## **Addendum No. 2**

### **INVITING SEALED BIDS ITB No. 21/10039**

#### **Project: West Campus Laboratories Bldg. F Renovation**

**Issue Date:** February 18, 2021

2 LARGE GROUP INSTRUCT. FLOOR PLAN  
RE: 1/2" PLAN FOR PARTITION TYPES SCALE 1/4"=1'-0"

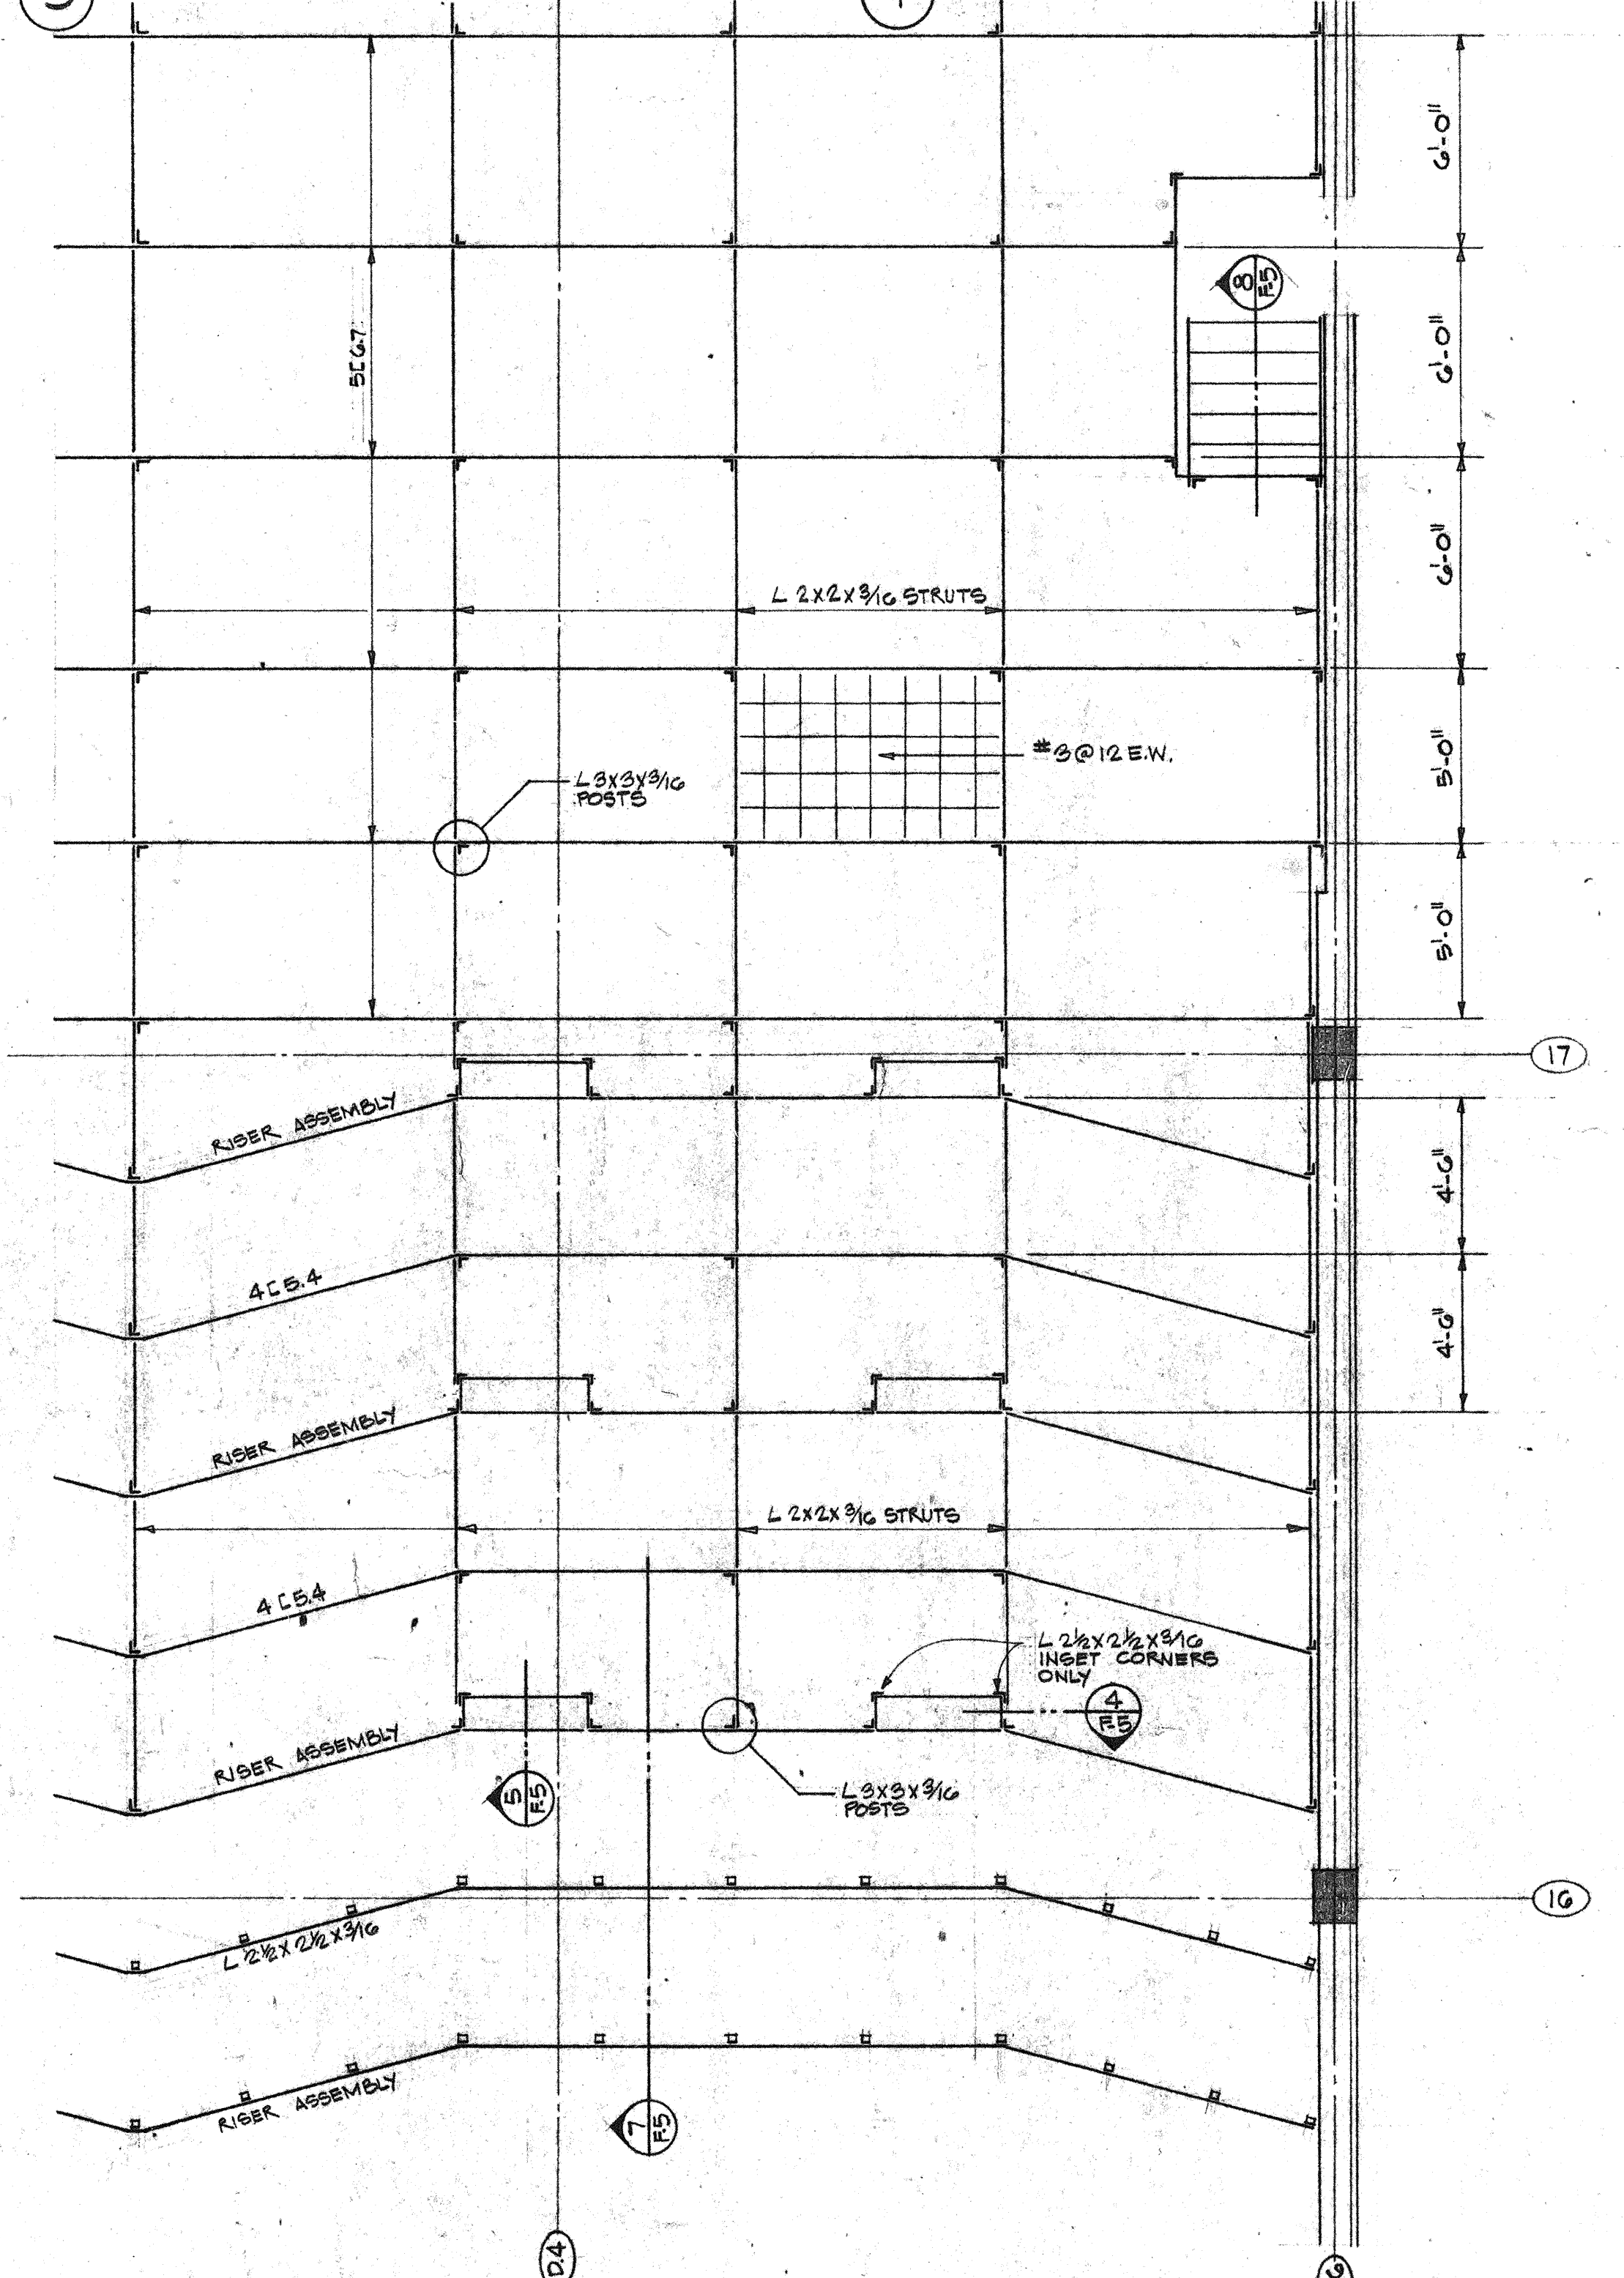
**Answer #5:** Roof Warranty is attached.
- Question #6:** Can As Built drawings of floor risers be provided to Contractors? What materials are the floor risers made of?

**Answer #6:** As built drawings F5 & F6, L GI DETAILS, have been added to the Addendum. Materials are called out on these drawings.
- Question #7:** Are the exterior Honeywell cameras to be salvaged?

**P2.1.1**  
100% CONSTRUCTION DOCUMENTS

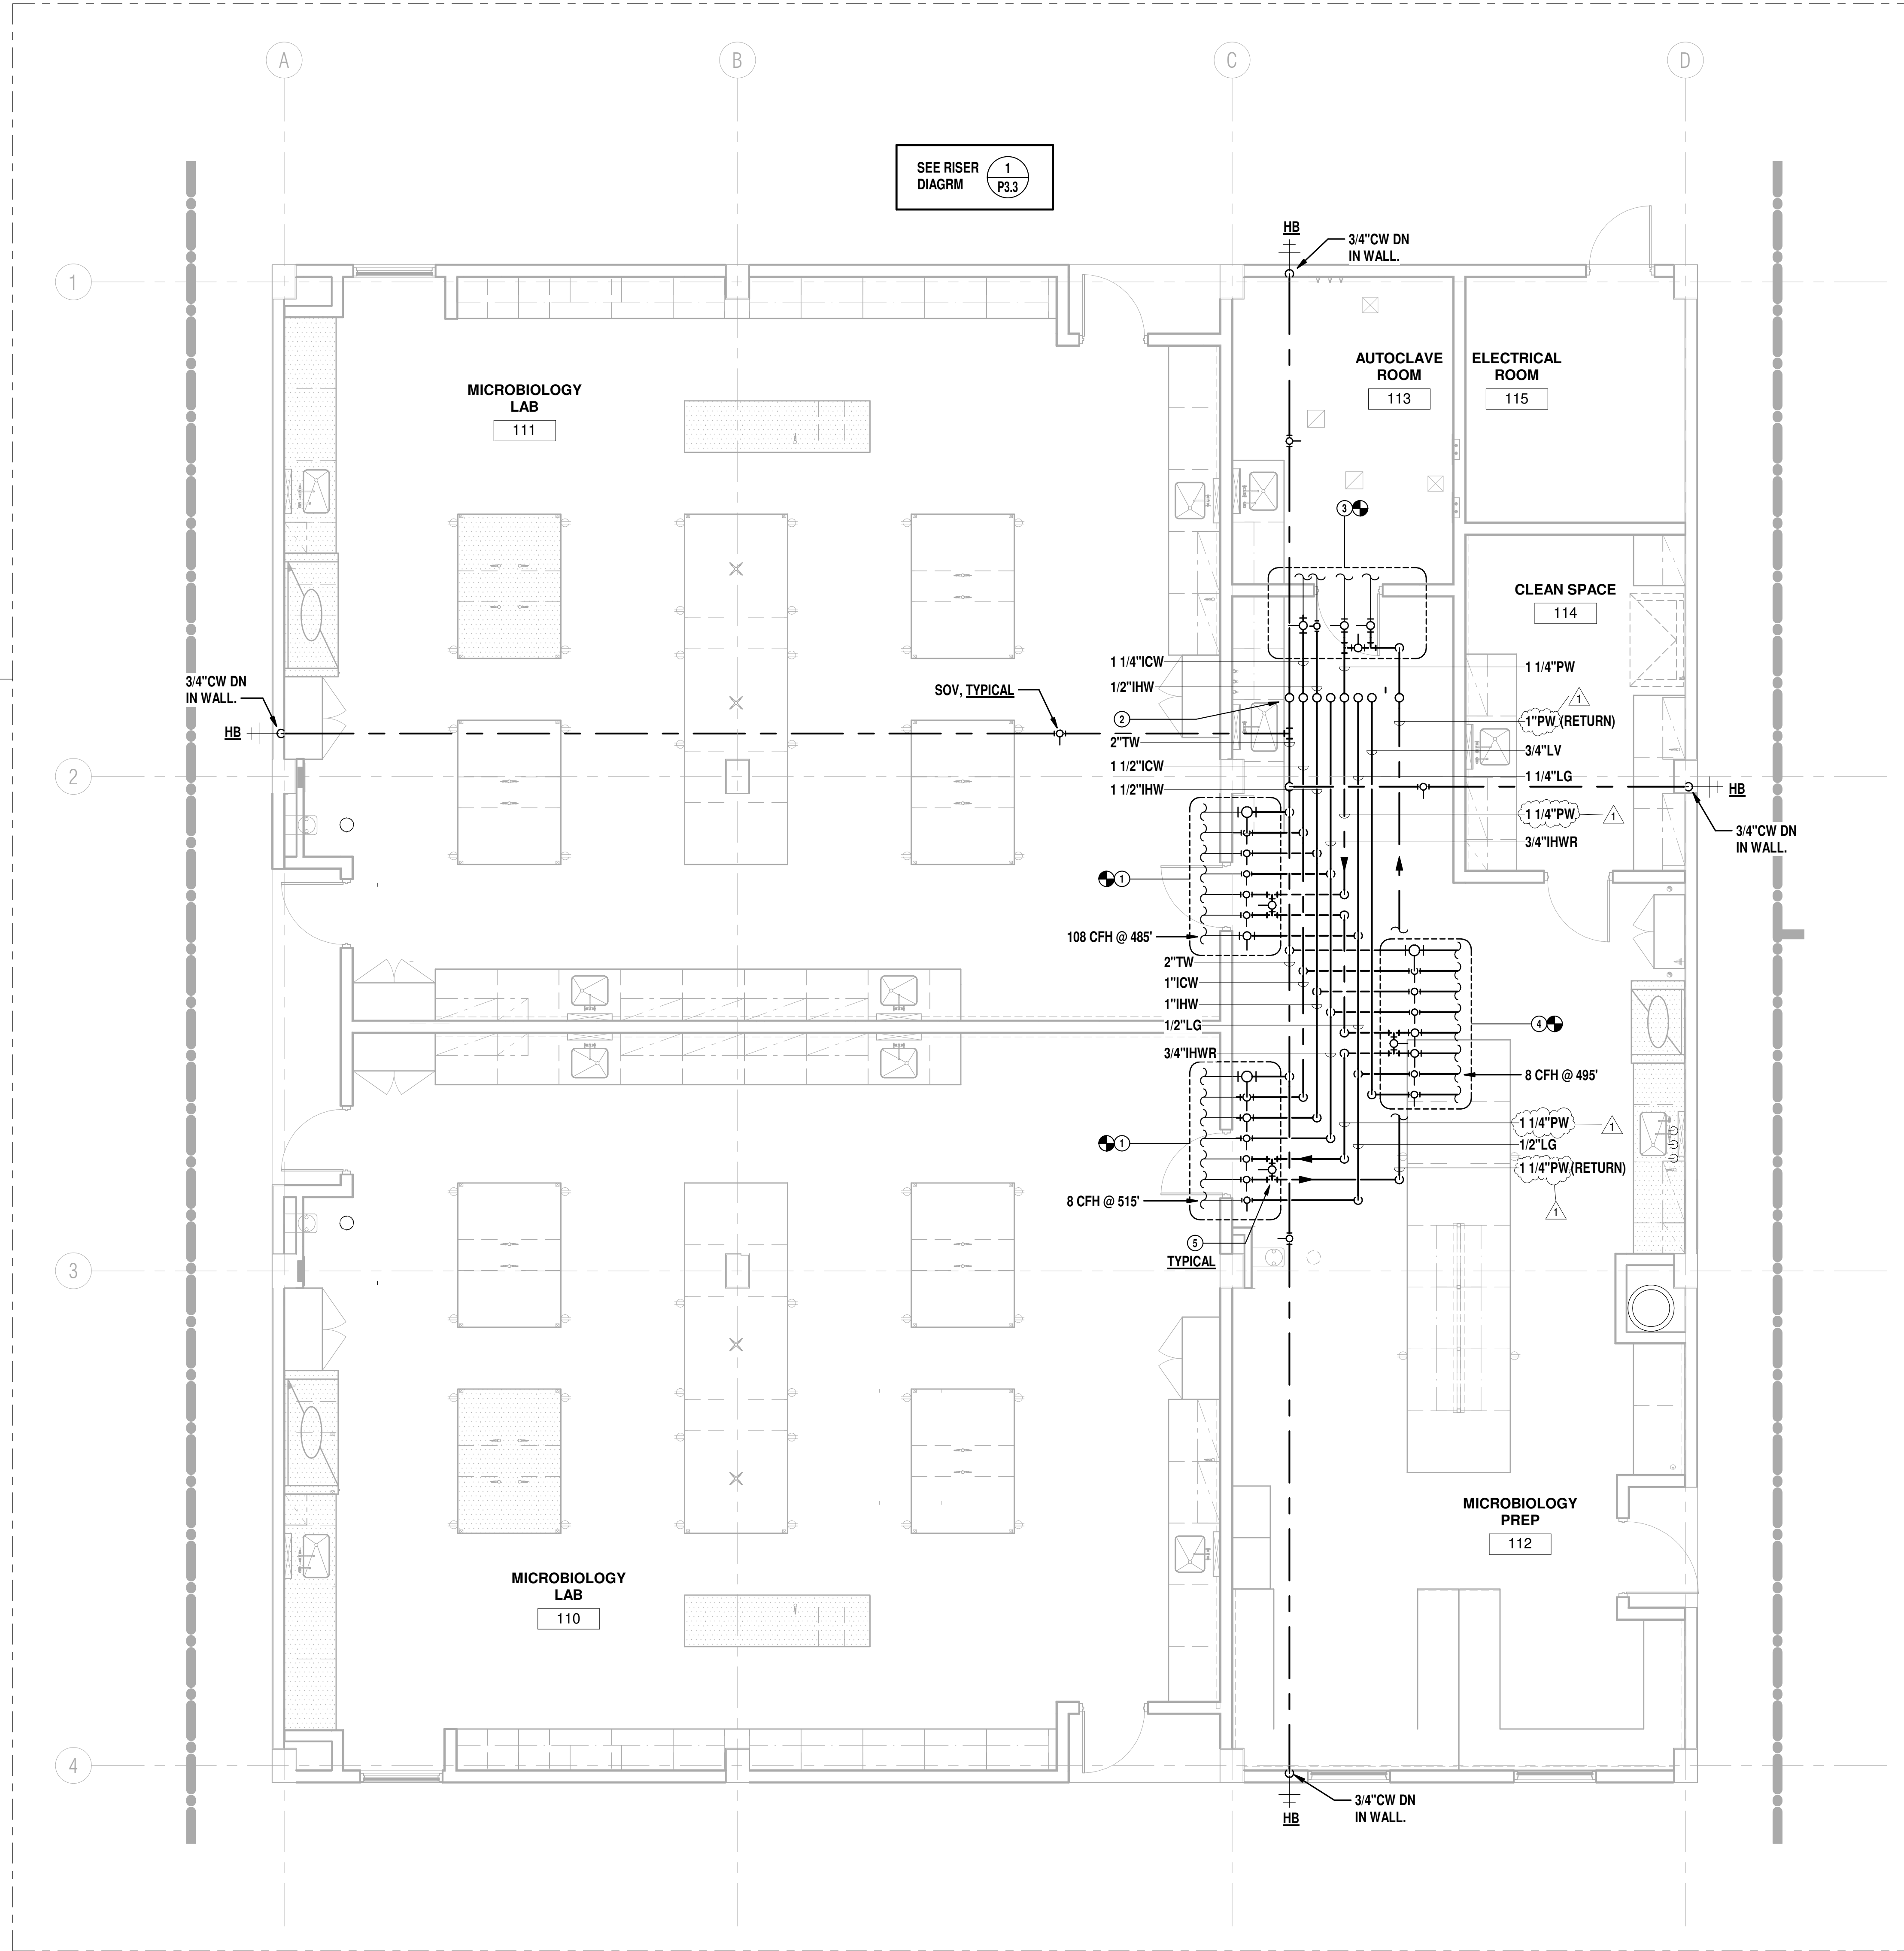
**Answer #8:** No shut-off valves into other buildings are located in Building F
- Question #9:** Fire risers – is the Contractor responsible for bringing in line and creating fire risers of Base Bid (Second Floor)? Are risers connected for Alternate 1, 2 and Base Bid? Or is the riser connection a T with Base Bid?

- Question #19:** Please Add Alternates to the MEP sheets they pertain to?
- Answer #19:** See Addendum 2 by BWS.
- Question #20:** Are the Add Alternates a pricing breakout? Or are they a true Add Alternate as if there is no funding for that work then that work will not happen?
